Item Name: Aft Crosstube - High

DRAWING NO. D212-664-241	TITLE CROSSTUBE ASSY (205/212 HI AFT)	REV. D	DART AEROSPACE LTD ENGINEERING ORDER		D.E.O. NO. D212-664-241-D-1	SHEET NO. SHEET 1 OF 2	SCALE NTS
DRAWN	CHECKED		MFG. APPR.		APPROVED	DE APPR.	
DATE 11.04.07	DATE 11.04.11		DATE 11.04.12		DATE 11/04/12	DATE 11.04.12

DRAWING NO. D212-664-241	TITLE CROSSTUBE ASS'Y (205/212 HI AFT)	REV. D	DART AEROSPACE LTD ENGINEERING ORDER		D.E.O. NO. D212-664-241-D-2	SHEET NO. SHEET 1 OF 1	SCALE NTS
DRAWN <i>97</i>	CHECKED <i>ASS</i>	MFG. APPR. <i>8</i>	APPROVED <i>MD</i>		DE APPR. <i>#</i>		
DATE 11.07.15	DATE 11.07.20	DATE 11.07.21	DATE 11/07/21		DATE 11.07.21

DART SERVICE INSTRUCTION

D212-664-241/-241B
ASSEMBLY DETAIL

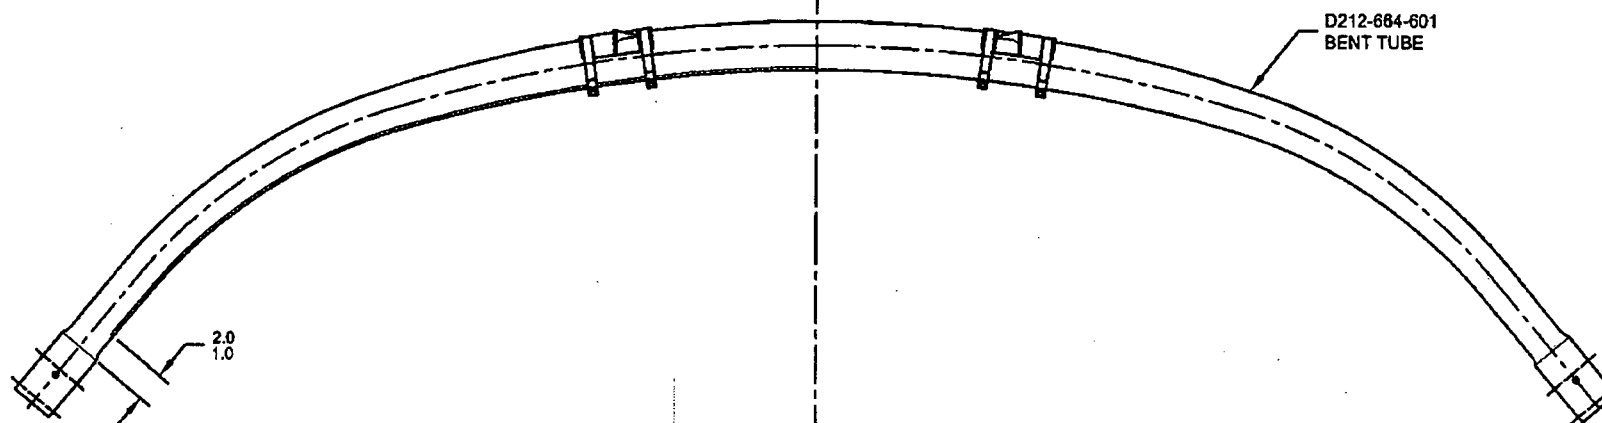
PURPOSE:

ADD AN INSPECTION WINDOW TO UNDERSIDE OF CROSSTUBE.

MASK AREA PRIOR TO PAINTING,
REMOVE MASKING AFTER PAINT
AND APPLY CLEAR COAT

- 2) FINISH: CHEMICAL CONVERSION COAT PER DART QSI 005 4.1
PRIME INSIDE AND OUTSIDE PER DART QSI 005 4.2
MASK UNDERSIDE OF CROSSTUBE AS SHOWN (HATCHED AREA) AND
PAINT OUTSIDE PER DART QSI 005 4.2
REMOVE MASKING AND APPLY CLEAR COAT

FIGURE 1: SUPPORT INSTALLATION

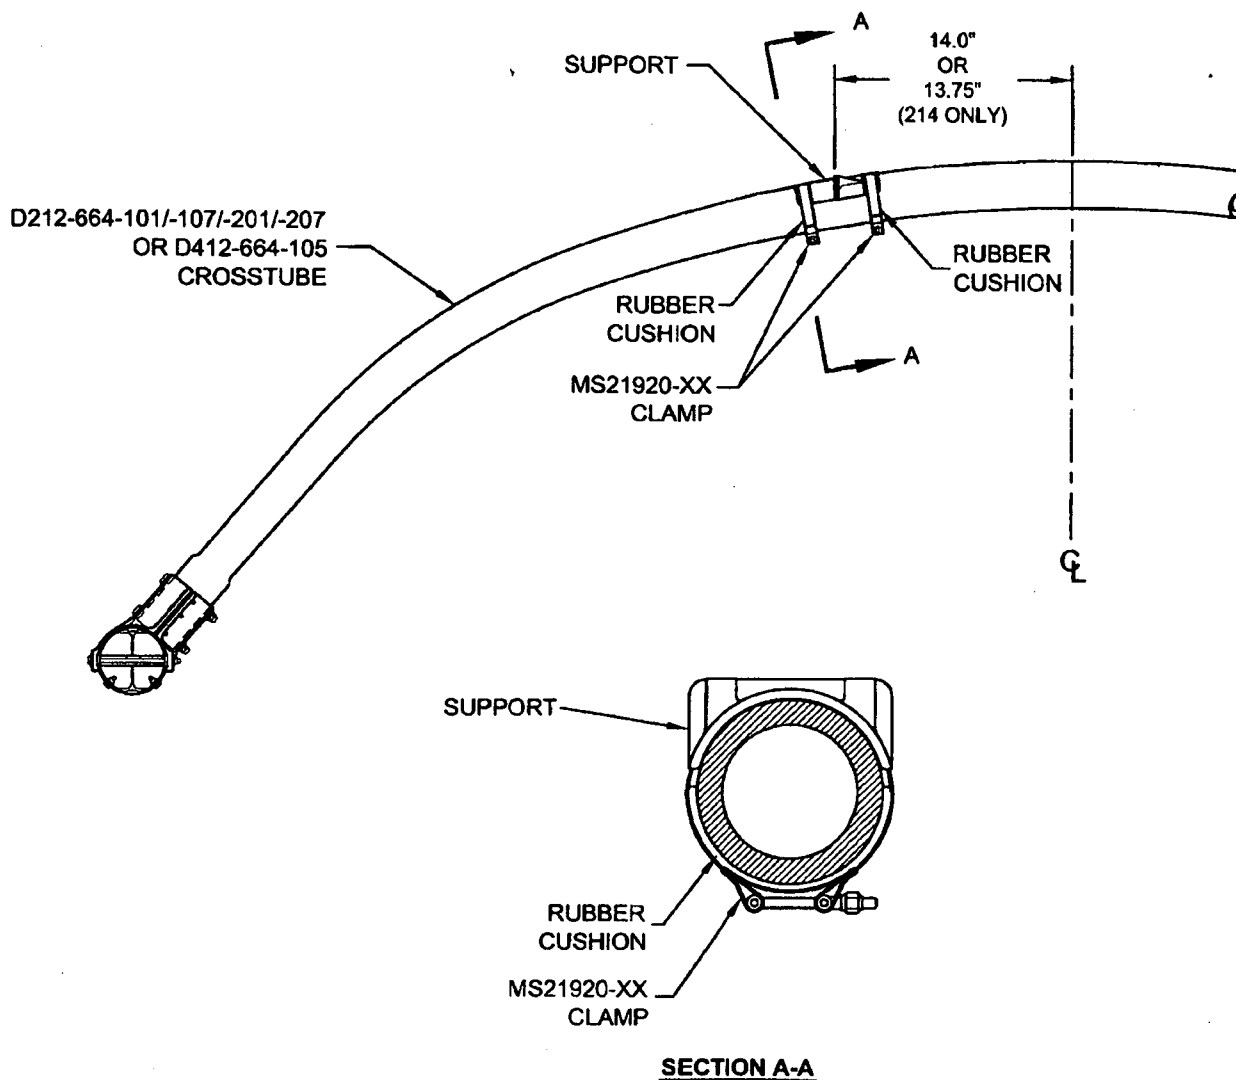
The supports on the following crosstubes are now installed using Proseal instead of Magnobond:

For the crosstubes listed above, section 32.4 of ICA-D212-664 is amended as follows. Use Figure 1 of this service instruction and Figures 32-2 to 32-9 of ICA-D212-664 for further reference. For crosstubes of an earlier change number, it is recommended that if the supports are removed, the supports should be reinstalled using the procedure listed below.

- 32.4.1 Locate the area on the crosstube for installation of support (see Figure 1 of this service instruction). For D212-664-101/-107/-201/-207 and D412-664-105 crosstubes, the outward face of the support tabs should be 14.0" (355mm) from the crosstube center for 204/205/210/412/UH-1 aircraft. For installation on 214B/B-1 aircraft, the outward face of the support tabs should be 13.75" (349mm). Ensure paint finish of crosstube is intact; touch up as required per Chapter 5 (5.3.9) of ICA-D212-664.

- 32.4.5 Apply a 0.04" to 0.07" thick layer of Proseal 890 Class B or AMS-S-8802 Class B sealant underneath applicable support and install support as shown in Figure 1 of this service instruction.

- 32.4.6 Install the clamps opposite to crosstube support as shown in section A-A of Figure 1. Install rubber cushions underneath each clamp around the bottom circumference of the crosstube up to the crosstube centerline. Torque clamps 80-100 in-lb (9.0-11.3 Nm). It is acceptable to use smaller or larger sized MS21920-XX clamps than those listed in ICA-D212-664, ensure that after torquing the clamps per this instruction, the nuts are in safety but not bottomed out

- 32.4.7 Prior to installing crosstube on aircraft, allow supports to cure for 72 hours and recheck torque on clamps.

CRUSHING OF DZIL-664-201

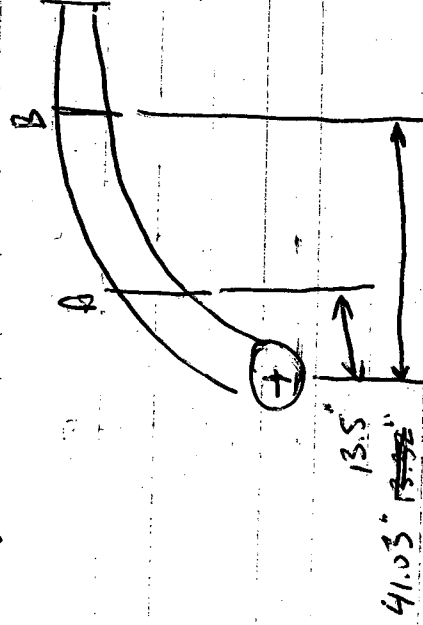
Acceptability of 8% CRUSHING

CRUSHING $(2.992 - 2.548) / (2.992 + 2.548) = 8\%$
 $I = 1.476 \text{ in}^4$

$MS = 14.32 / 11.65 - 1 = 0.22$

The will fail at support before area of 8% CRUSHING, 8% CRUSHING AT END OF BEND IS ACCEPTABLE
